**Application for Permission under Section 16 of the Town Planning Ordinance (Cap.131)  
For Minor Relaxation of Building Height Restriction from 2 Storeys to 4 Storeys  
For a Proposed 4-Storey Columbarium  
At Part of Inland Lot No. 7755 RP and Government Land  
sandwiched between Inland Lot Nos. 7755 RP and 7713 (altogether “the Site”)  
Cape Collinson Road, Chai Wan, Hong Kong  
(Planning Application No. A/H20/200)**

Application for Permission under Section 16 of the Town Planning Ordinance (Cap.131)  
 For Minor Relaxation of Building Height Restriction from 2 Storeys to 4 Storeys  
 For a Proposed 4-Storey Columbarium  
 At Part of Inland Lot No. 7755 RP and Government Land  
 sandwiched between Inland Lot Nos. 7755 RP and 7713 (altogether "the Site")  
 Cape Collinson Road, Chai Wan, Hong Kong  
 Response to Departmental Comments

**RESPONSE-TO-COMMENTS TABLE**

### **Landscape and Visual Impact Assessment and Landscape Proposal**

*COMPENSATORY PLANTING PLAN*

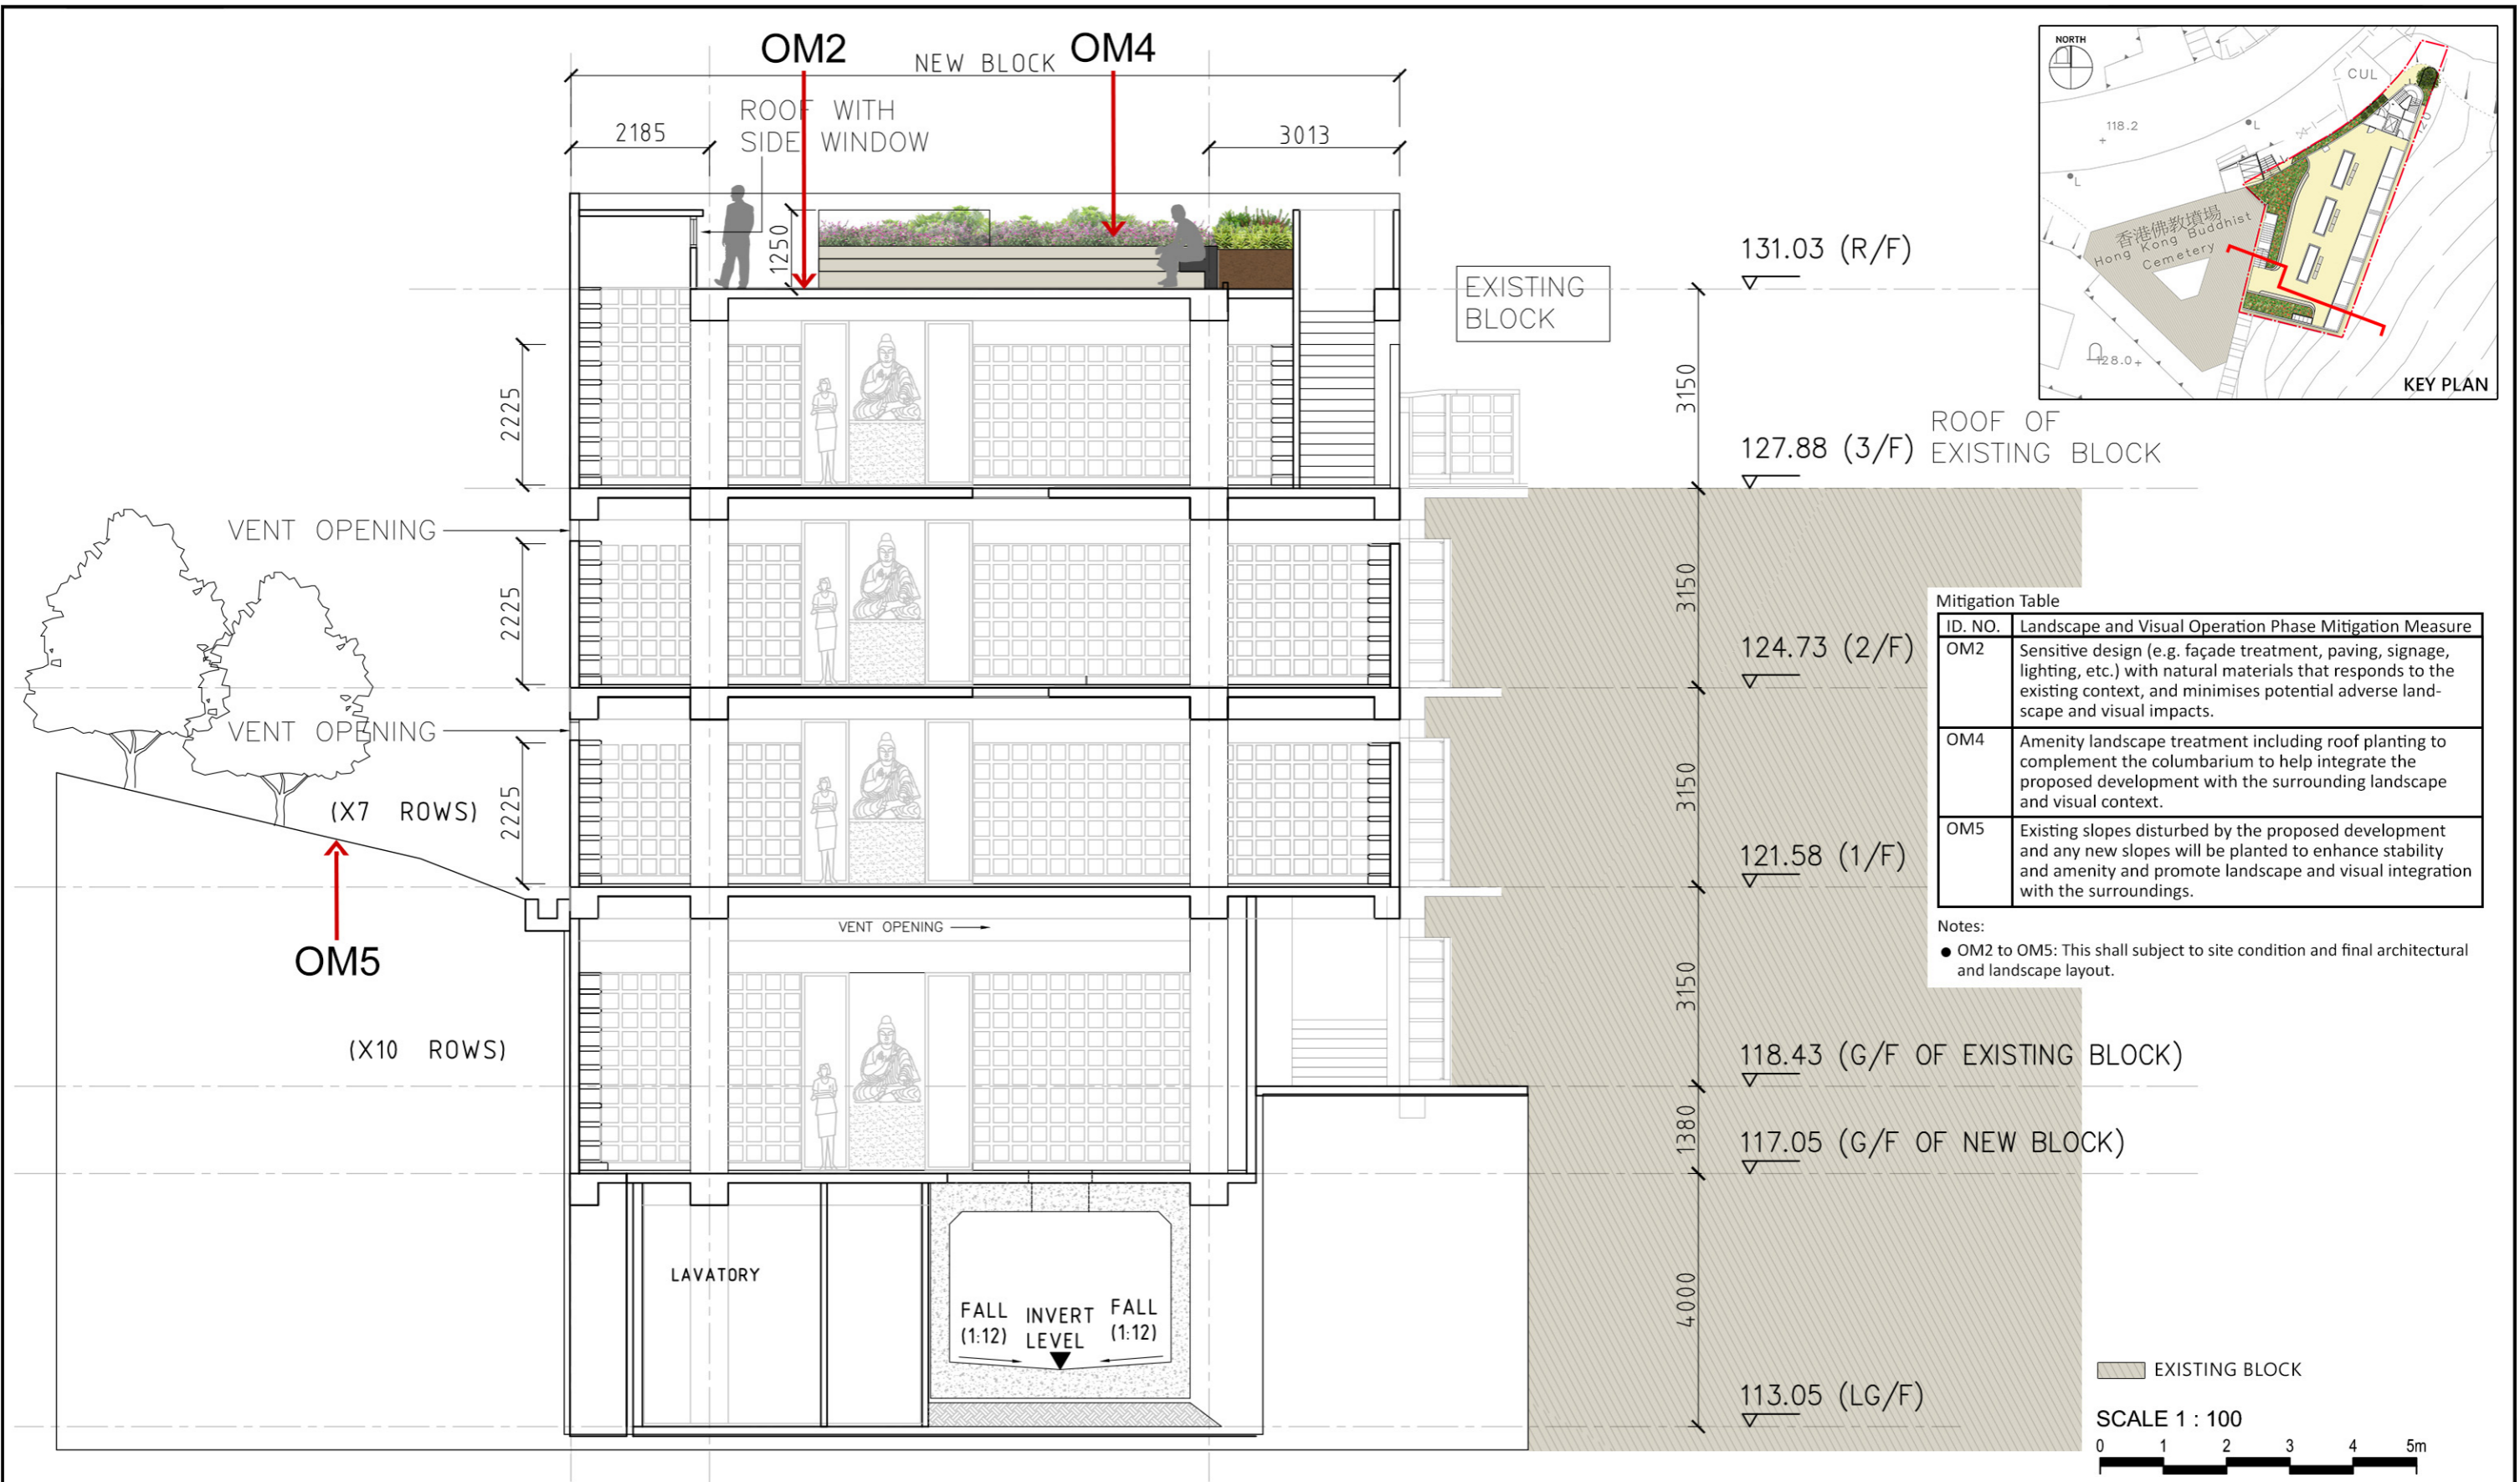
Item	Departmental Comments	Responses
	<p><u>and Removal Proposal (TPRP)</u> prepared in accordance with LAO LDPN No. 6/2023 (Para. 2.1.1 and 3.2.2 refer) is provided. The applicant is advised that a full TPRP in accordance with the abovementioned requirements is <u>not</u> required for s.16 application. The applicant should make reference to para.28 of the guidance notes for application under s.16, Annex B for further details regarding the requirement of the landscape submission and PlanD’s PNPP No. 1/2019 for the required tree information. The report should be revised as appropriate.</p>	<p>requirement of the guidance notes for application under s.16 and Annex B and PlanD’s PNPP No. 1/2019.</p>
<p>UD&amp;L, PlanD 7</p>	<p>It is noted that the tree compensation ratio (i.e. 1:0.17 in terms of tree number) is far less than the ratio of 1:1. The applicant should review the development layout to maximise the tree planting opportunity. Moreover, 4 out of the 5 new tree plantings are not broad leaf trees. The applicant should provide more broad leaf trees of native species to mitigate the loss of native tree species.</p>	<p>The landscape layout has been revised to maximise the tree planting opportunity. The planting area on ground floor has been extended to the entrance at the northeastern tip of the Site which enables to add 1 no. standard tree. The revised tree compensation ratio is 1:0.20 with 6 nos. of compensatory tree plantings. <i>Sapium sebiferum</i>, a native broad leaf tree is proposed as an alternative for new tree plantings. Para. 4.3.9, 4.3.12 and Table 6.3.3 in the report and Drawing No. HKBA1-CP01 in Appendix C of the report have been revised.</p>
